Access Compliance Report

Public Rights-of-Way

(Curb Ramps)

Intersection ID: 2864	Main Street: ROCK_STREAM_DR	Cross Street: WAVERLY_LYNN_LN	Location:	N
ADA ID: C47CA56E8F11	Ramp Type: Perp	Initial Pass/Fail: Fail	Overall Compliance: No	Severity Score: 10
Codes/Mitigation Info/Possible Solution		Field Measurements/Component Compliance

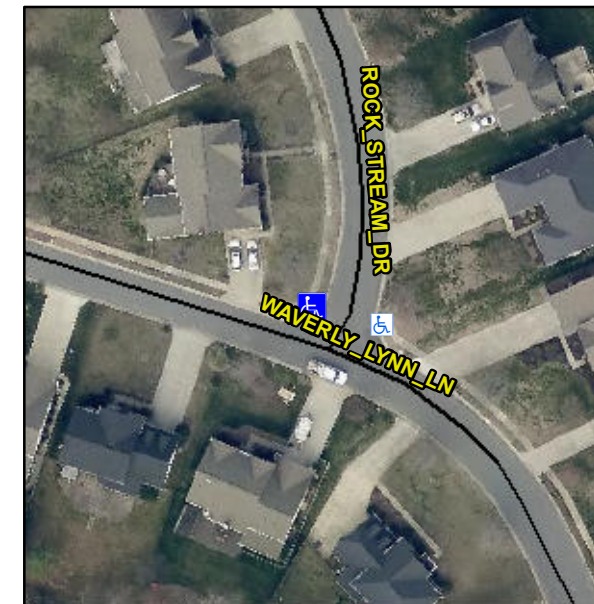
Not Found, R304.5.1, R304.5.3

Compliance	Description	Data	Compliance	Description	Data
N/A	Ramp Length (in)	48.0	Yes	Ramp Slope (%)	7.4
No	Ramp Width (in)	40.0	No	Ramp XSlope (%)	2.2
N/A	Flare Type LT	N/A	N/A	Flare Type RT	N/A
N/A	Flare Slope LT (%)	N/A	N/A	Flare Slope RT (%)	N/A
N/A	Flare Traversable LT?	N/A	N/A	Flare Traversable RT?	N/A
N/A	Landing Length (in)	N/A	N/A	DWS Provided?	N/A
N/A	Landing Width (in)	N/A	N/A	DWS Contrast?	N/A
N/A	Landing Slope (%)	N/A	N/A	DWS Length (in)	N/A
N/A	Landing X Slope (%)	N/A	N/A	DWS Full Width?	N/A
N/A	Landing Curb? (Y/N)	N/A	N/A	DWS Offset (in)	N/A
N/A	Shared Landing?	N/A			
N/A	Gutter Ponding?	N/A	N/A	Gutter Slope (%)	N/A
N/A	Gutter Lip Ht (in)	N/A	N/A	Gutter X Slope (%)	N/A
N/A	Painted X Walk1?	No	N/A	Painted X Walk2?	N/A
	X Walk 1 Direction	To SE		X Walk 2 Direction	N/A
N/A	X Walk 1 Width (in)	N/A	N/A	X Walk 2 Width (in)	N/A
	X Walk 1 Slope (%)	5.4		X Walk 2 Slope (%)	N/A
	X Walk 1 X Slope (%)	3.6		X Walk 2 X Slope (%)	N/A

Remove & Replace Entire Ramp.
